15 For Review and Reconsideration of Failure to
16 Act on the Application for Section 401 Water
17 Quality Certification of the City of Palo Alto
18 Municipal Golf Course Reconfiguration
Project in the City of Palo Alto, Santa Clara
County ,

**PETITION FOR REVIEW AND
RECONSIDERATION**

Subject: Incomplete Application for Water Quality Certification for the City of Palo Alto
Municipal Golf Course Reconfiguration Project in the City of Palo Alto, in Santa Clara
County

Subject: Second Incomplete Application for Water Quality Certification for the City of Palo Alto Municipal Golf Course Reconfiguration Project in the City of Palo Alto, in Santa Clara County

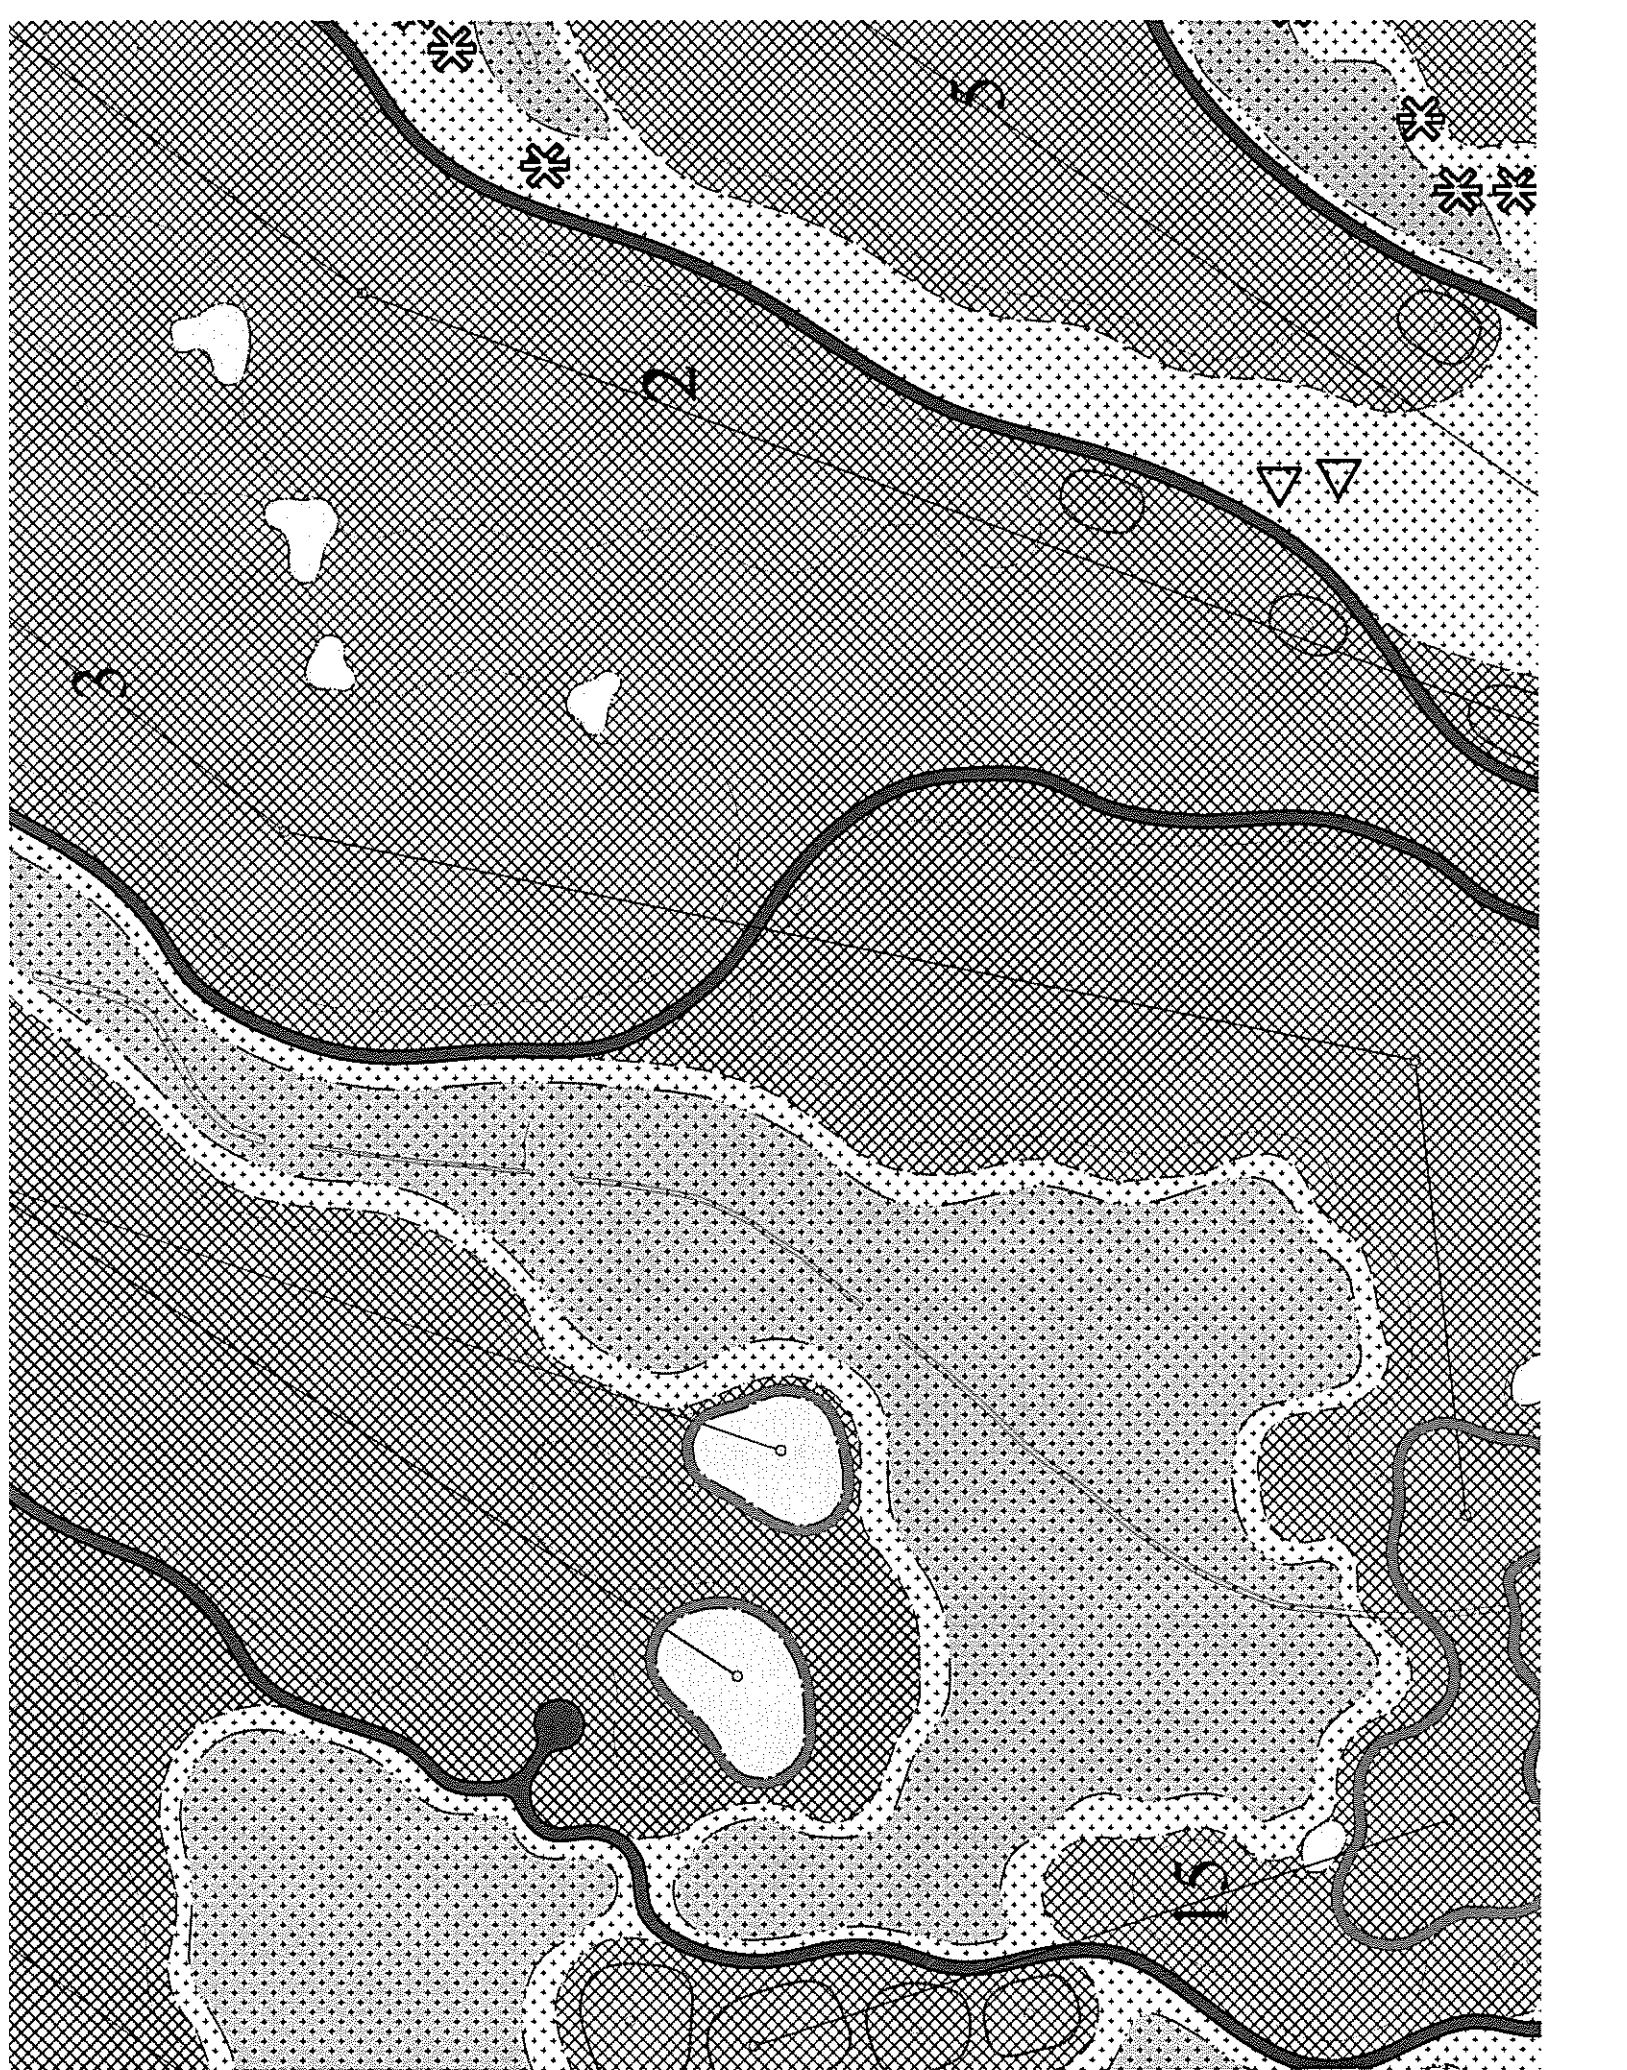
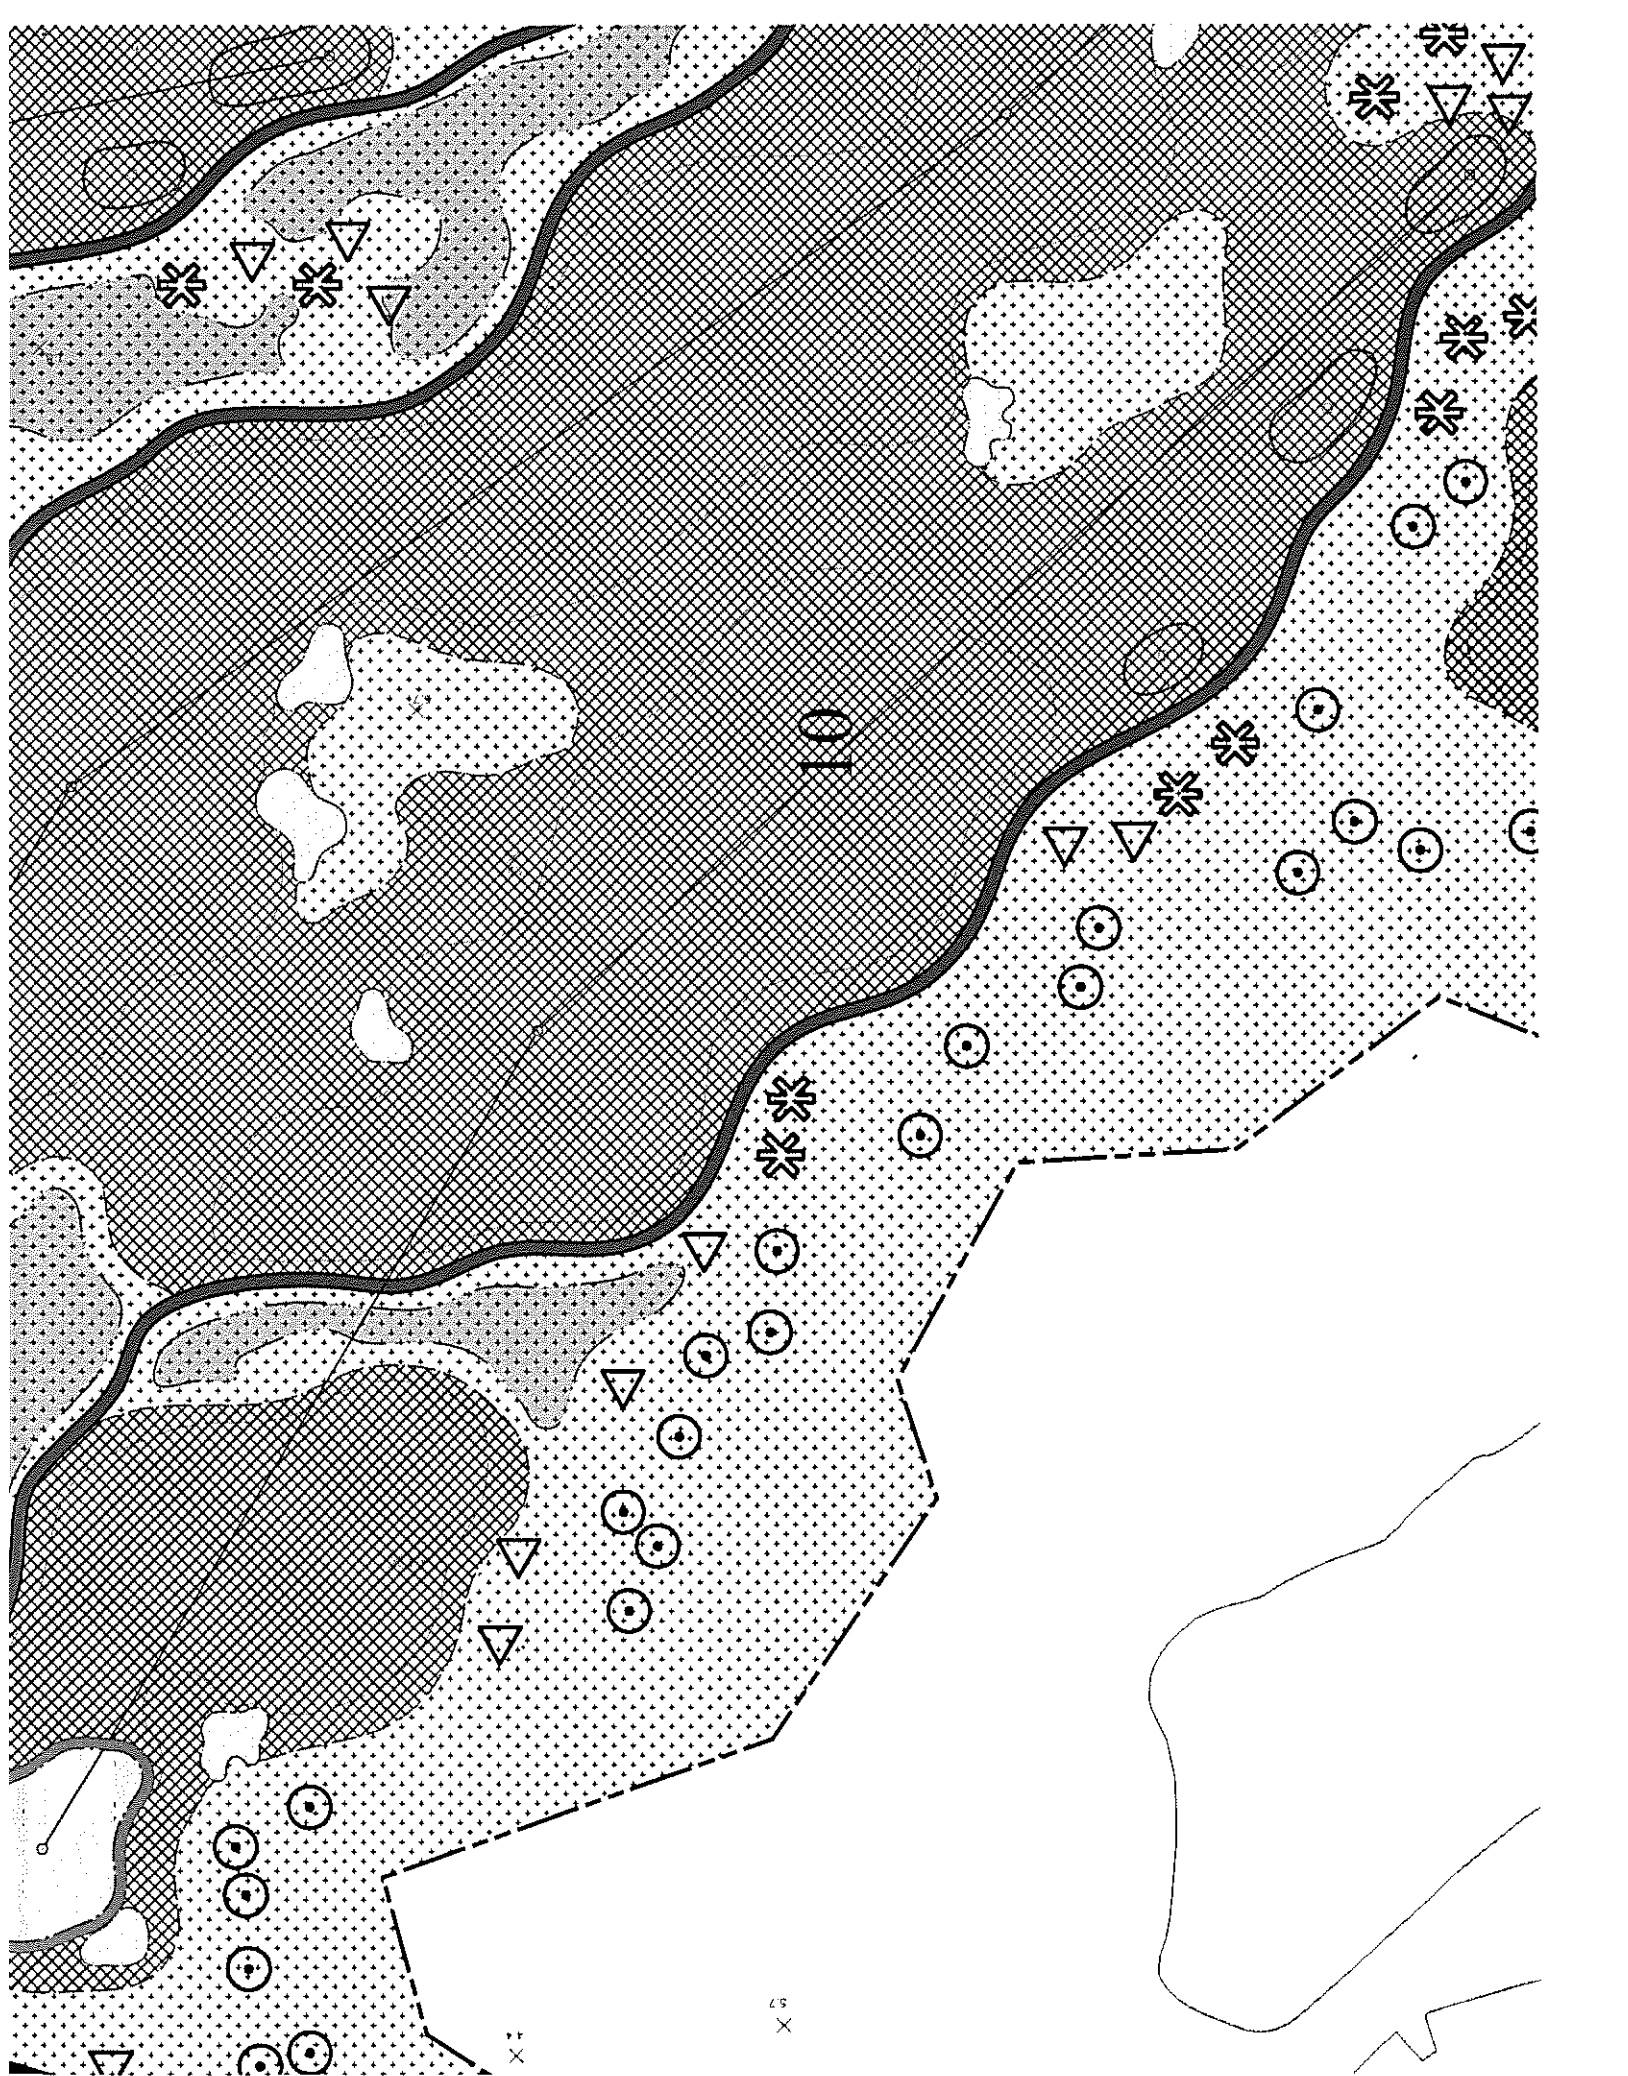
The supplemental materials acknowledge that the Project site's jurisdictional delineation for wetlands has not yet been verified by the U.S. Army Corps of Engineers (Corps) and that the mitigation proposal will be refined after the delineation is verified. The Water Board will not issue a Clean Water Act Section 401 water quality certification on the basis of a conceptual mitigation plan. Only a final mitigation plan, with detailed design information and performance criteria, is sufficient to support certification

The supplemental application materials state that the City of Palo Alto will develop a Mitigation Monitoring and Reporting Plan (MMRP) for the Project. Prior to issuing a Clean Water Act Section 401 water quality certification to the Project, the Water Board must be provided with a complete MMRP for review and approval. Certification will not be issued until the Water Board has determined that the MMRP is appropriate to ensure the success of the mitigation wetlands.

Response 3B: As the wetlands on the Golf course are well defined, the City has a high level of confidence that wetlands are fully delineated and that the proposed plan for the Golf Course, including wetlands will not need to be altered. While the full delineation of the Golf Course is not verified, Ian Liffmann of the USACE San Francisco District did verify the wetlands for the SFCJPA project, which includes a portion of the Golf Course, on February 5, 2013, and the verification did not result in any changes or revisions to wetlands on the Golf Course.

Response: An MMRP specific to the wetland impacts is being prepared as requested and will be provided to the RWQCB no later than February 14, 2014.
